From: [REDACTED]
Sent: 26 January 2026 12:13
To: Andy Watt
Cc: [REDACTED]
Subject: Re: 2026.01.07 Re: DM/25/3059 - Badgers Brook, London Road, Bolney Haywards Heath, West Sussex RH17 5PY

Subject: 2026.01.07 Re: DM/25/3059 - Badgers Brook, London Road, Bolney Haywards Heath, West Sussex RH17 5PY

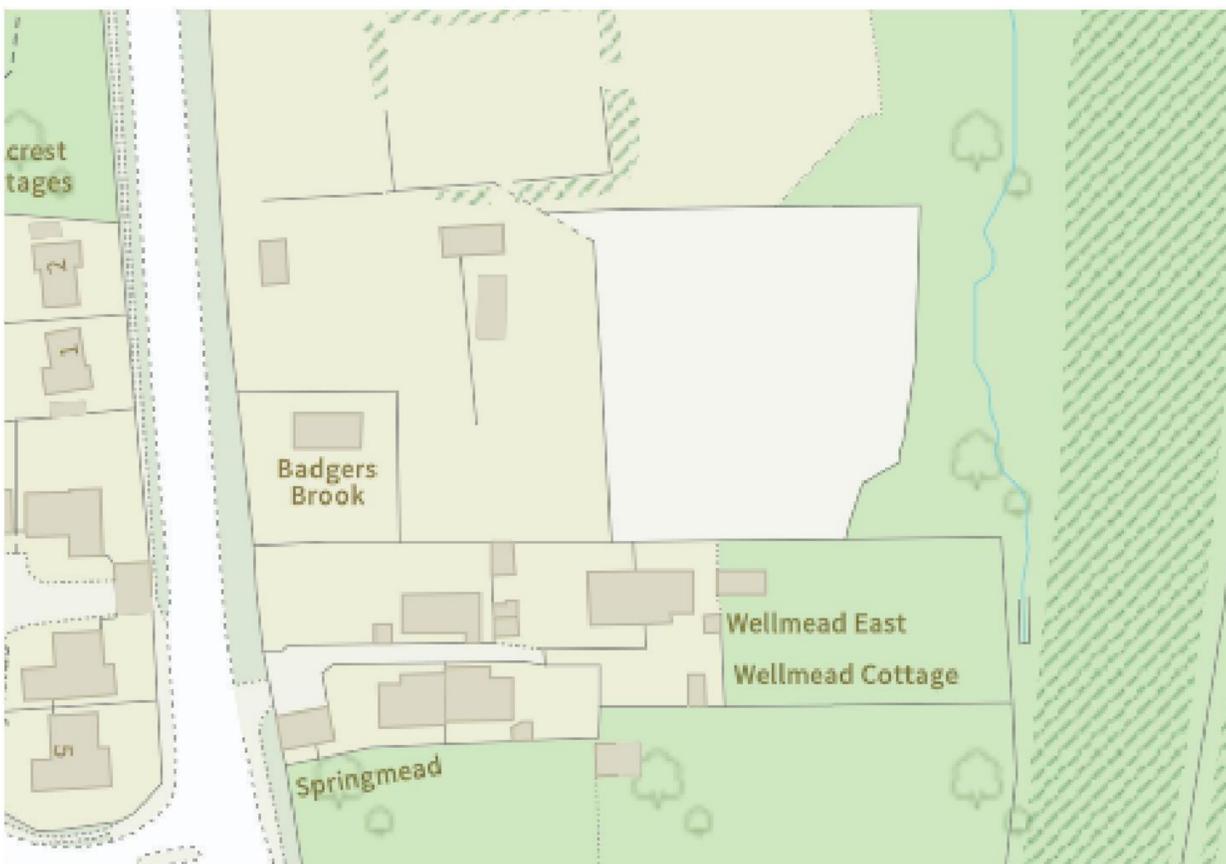
I have had a look on the maps and it appears that the watercourse flows into a pipe just south of the site...

But I can't find any evidence of where it might emerge again downstream.

Our proposed discharge rate is very low, so we may be able to deal with this with some photos, especially if they can show water flowing along the ditch, and a quick measurement of the ditch dimensions and the pipe, however they may want it traced downstream. That said it is marked as a 'stream' on the survey, which suggests something quite substantial, but there is not much detail.
